ADDENDUM No. FOUR

Date:	June 20	. 2024
Date		,

Project: Flemington Road Improvements, MES No. 2023-80

C301

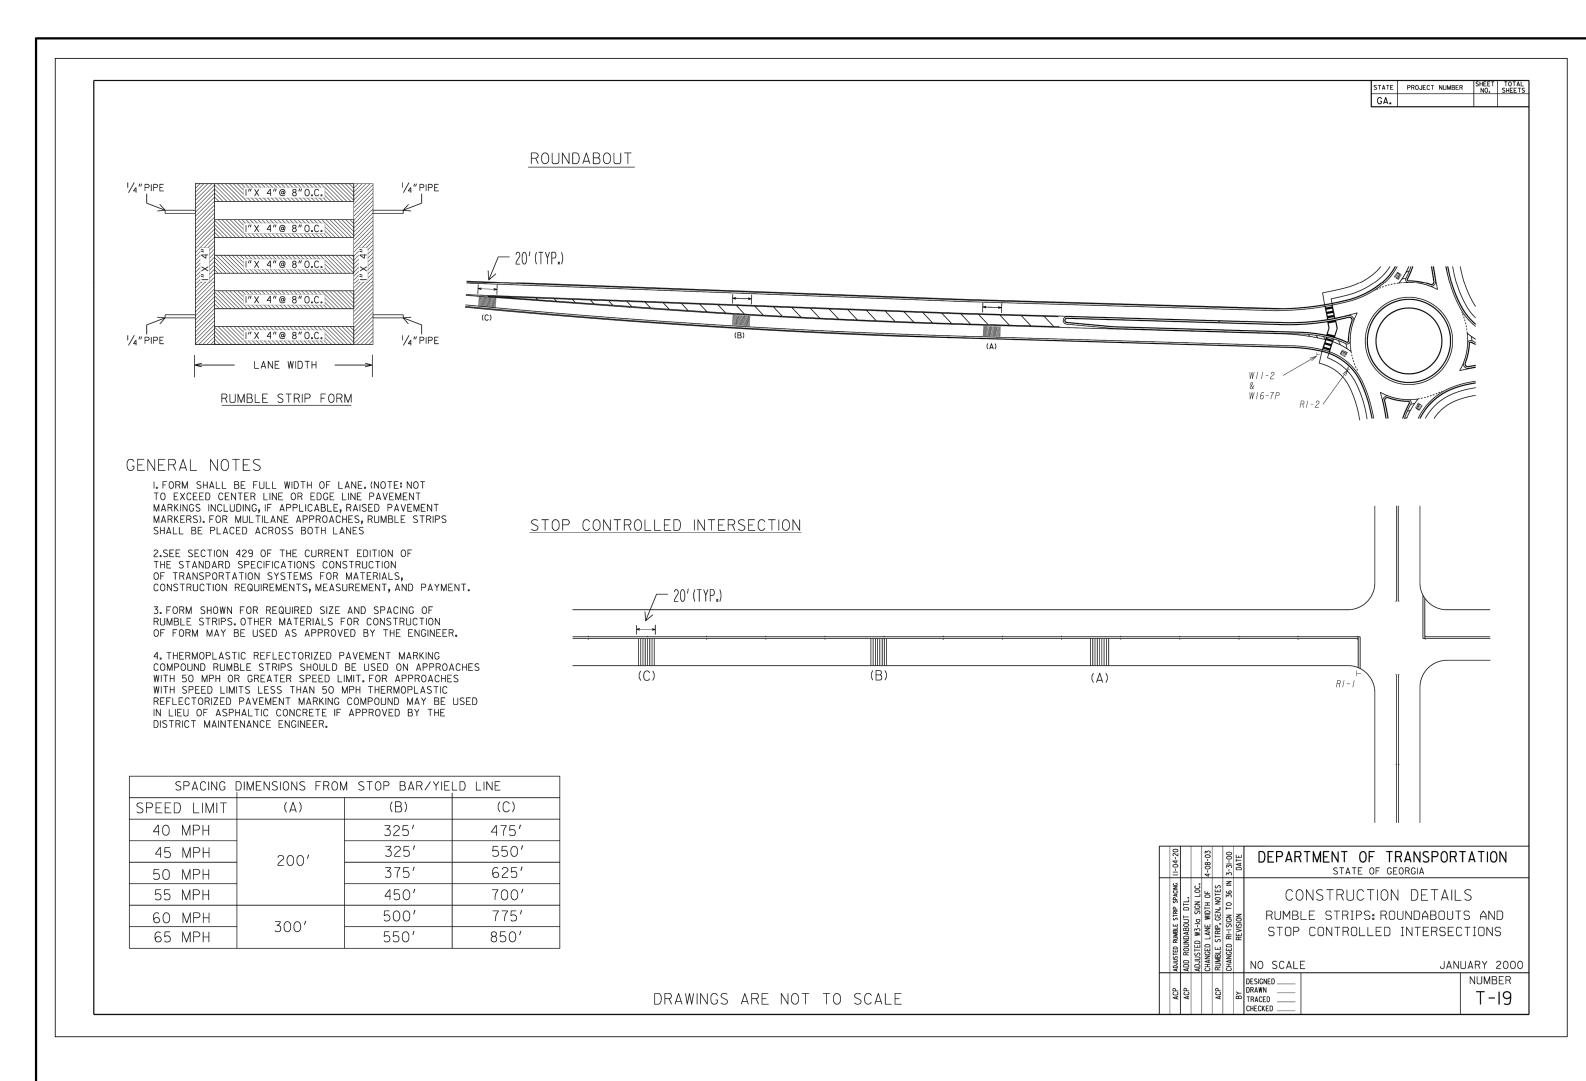
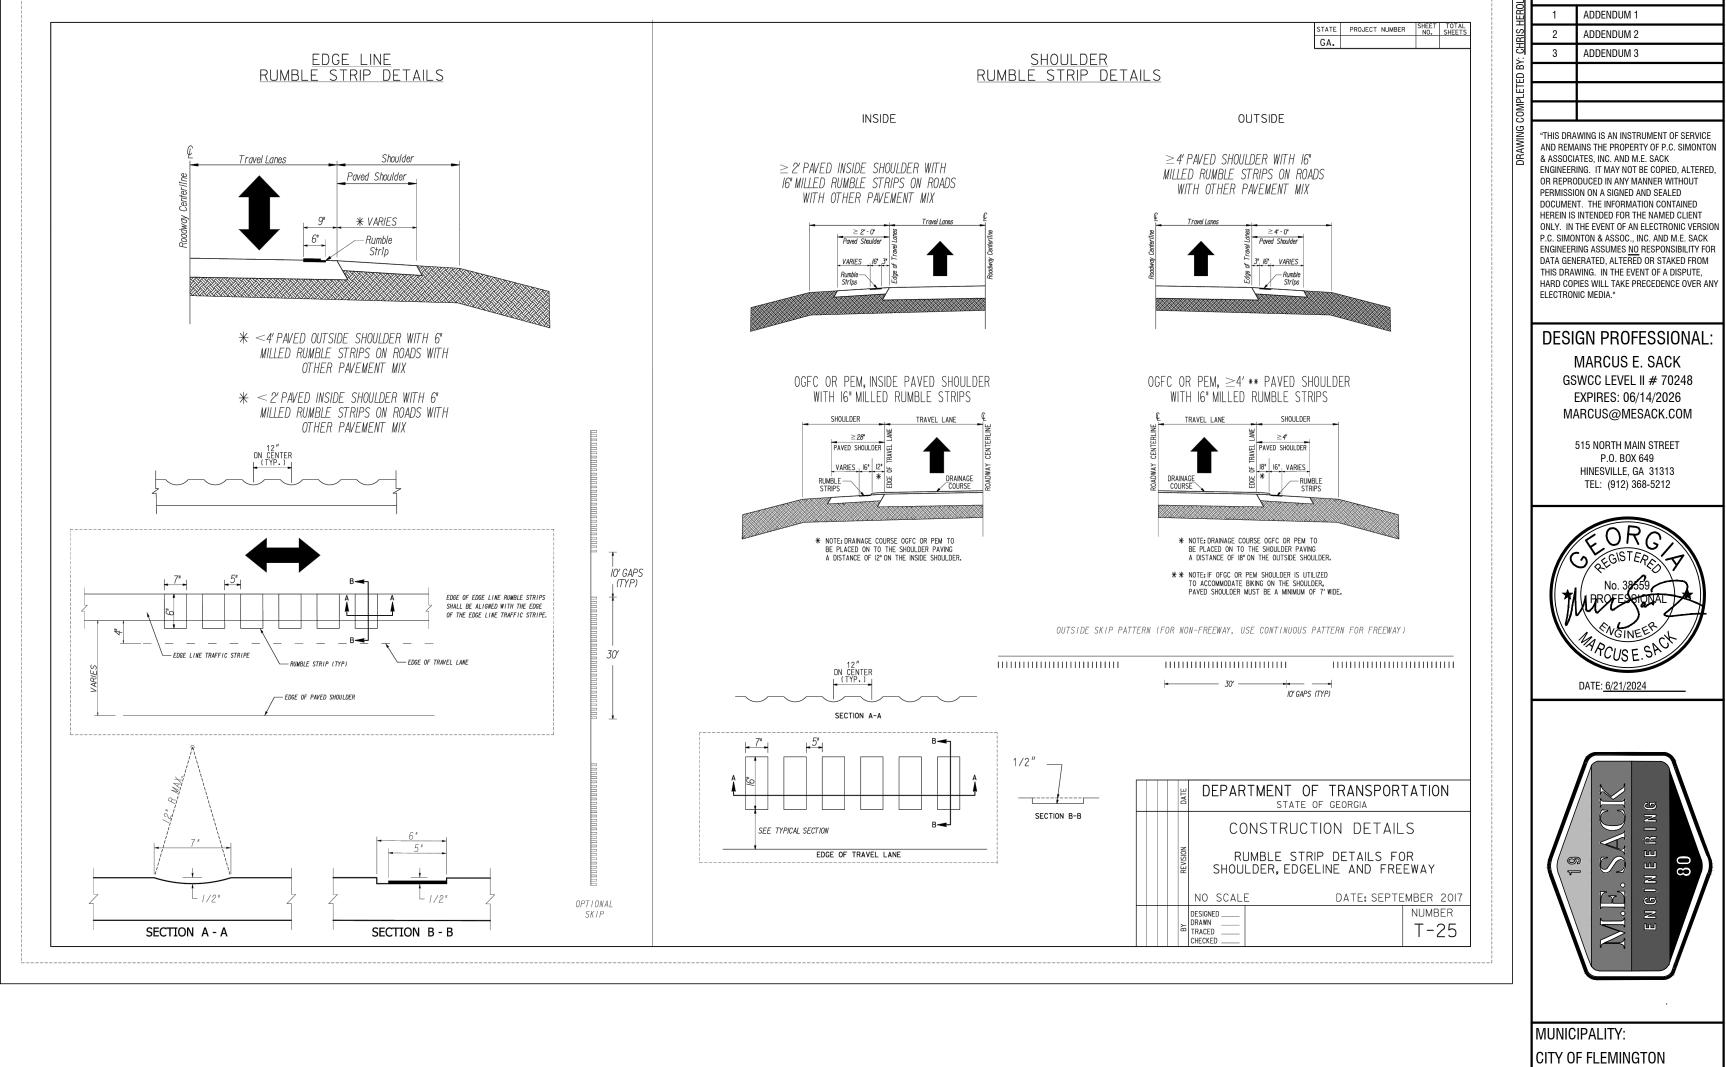
Replace the entire plan set with enclosed of the same. Note the Engineer has decided to clip sections of the Cement Stabilized Reclaimed Base (CSRB) where existing elevations must be met and a taper of the CSRB is needed to tie in. The Engineer updated plan sheet C300 to reflect an additional detail for a concrete driveway section, and has added sheet C301 with GDOT details T-19 and T-25.
